# Hillsborough County Florida

## SM STAFF REPORT

<b>SUBJECT:</b>	MM 19-0521	<b>PLANNING AREA:</b>	East Lake – Orient Park
<b>REQUEST:</b>	Major Modification to an Approved PD	<b>SECTOR</b>	Central
<b>APPLICANT:</b>	Bosra Development LLC		
<b>Existing Zoning:</b> PD 80-0090		<b>Comp Plan Category:</b> CMU-12

## Application Review Summary and Recommendation

**20F3**  
Sheet No.: 01-26-19

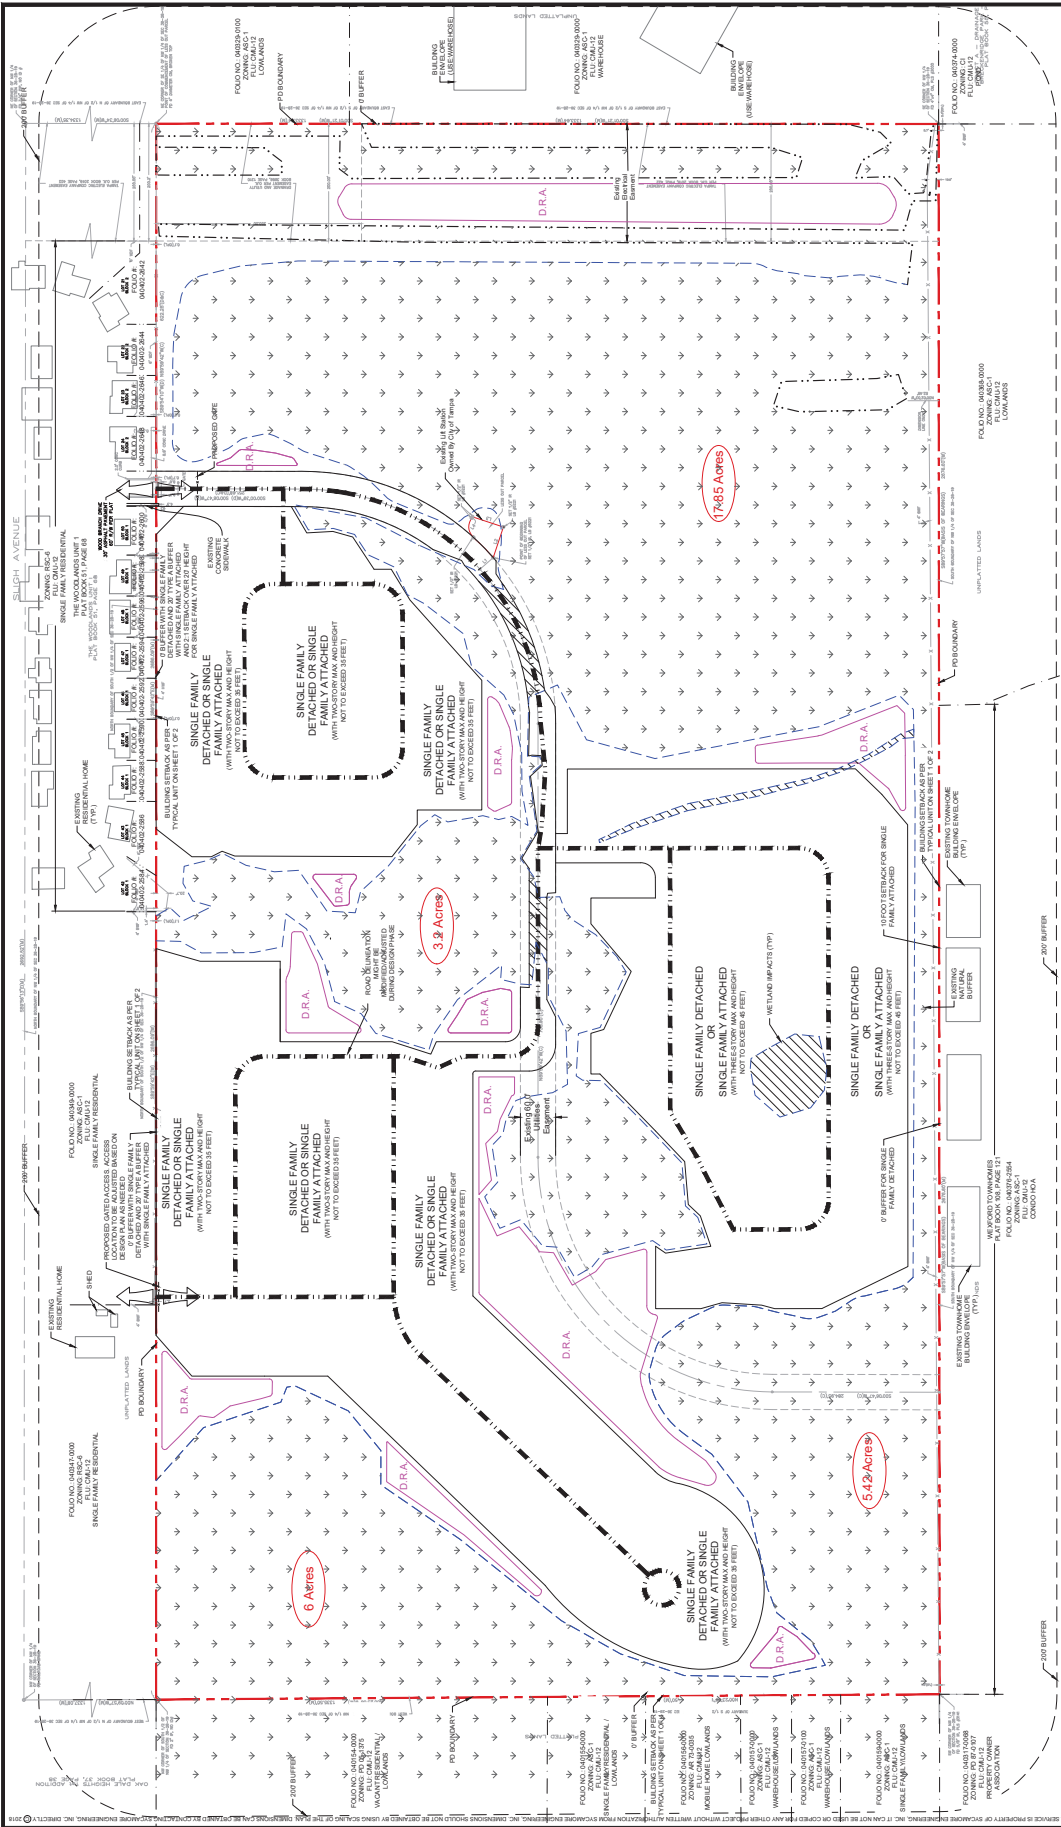
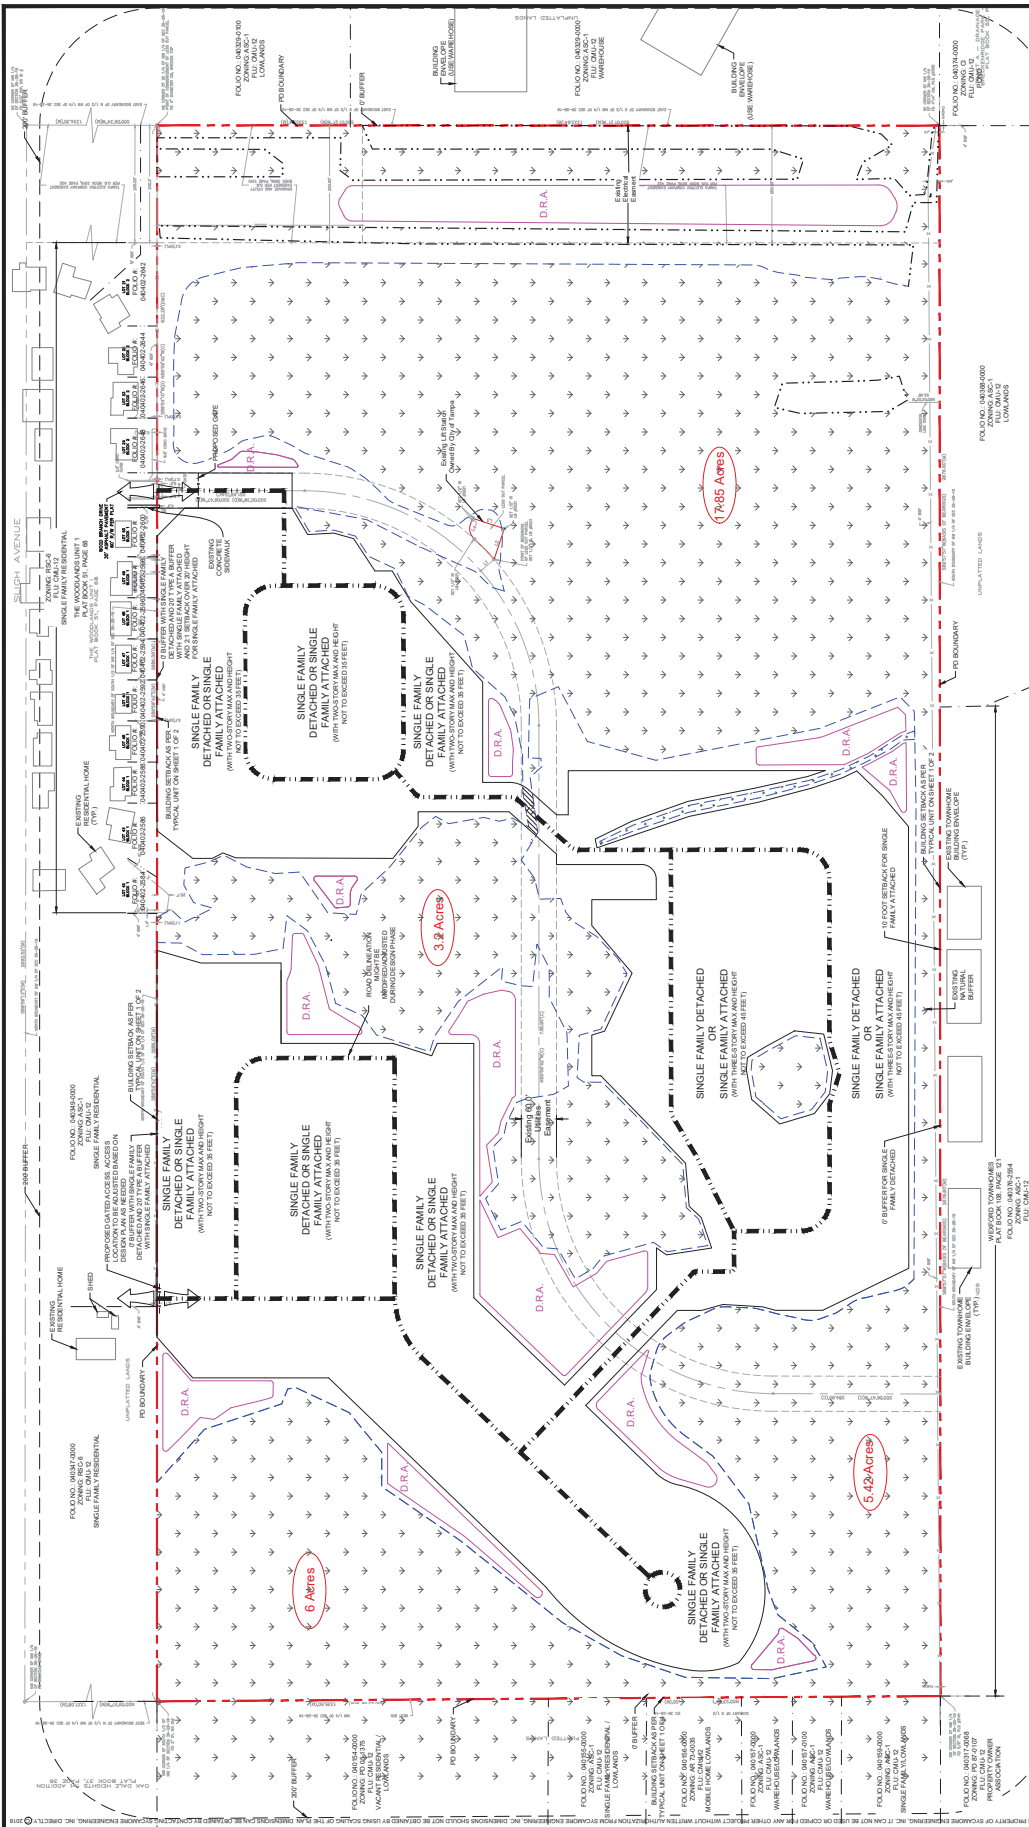
- ~~1. Remove "Typical Lot Layout B" from Sheet 1 as it is identical to "Typical Lot Layout A."~~
- ~~2. "Typical Lot Layout A" to be revised to "Typical Lot Layout."~~
- ~~3. Sheet 1's "Multi-family Attached Unit Layout" to be revised to match Sheet 2's "Development Use Matrix" development standards.~~
- ~~4. Sheet 1's "General Development Plan - 40' Lot" to be revised in compliance with conditions.~~

- ~~5. Sheet 1's "General Development Plan" to be removed.~~
- ~~6. Site Data Table on Sheets 2 and 3 to state proposed use as Single Family Detached & Single Family Attached (Townhomes).~~

- ~~7. Development Use Matrix on Sheets 2 and 3 to remove Floor Area Ratio row.~~
- ~~8. Note 1 on Sheets 2 and 3 to be removed.~~
- ~~9. Note 2 on Sheets 2 and 3 to be revised to allow a maximum of 8 attached units.~~

- ~~10. Notes 6 and 7 on Sheets 2 and 3 to be removed.~~
- ~~11.~~ 11. The following notations along southern PD boundary on Sheets 2 and 3 to be removed:

- 0' buffer for single-family detached.
  - 10' setback for single-family attached.
  - Building setbacks as per Typical Unit on Sheet 1 of 2.
2. General Development Plan – 40' Lot Detail to be removed.

3. Typical Lot Detail to be modified in accordance with or note conditions #2, #3, and #3.1 - #3.7
4. Multi-Family Attached Unit Detail to be titled "Single-Family Attached Detail" and modified in accordance with or note conditions #4, #4.1 and #4.2

5. Development Use Matrix on Sheets 2 and 3 to be updated to reflect conditions of approval.
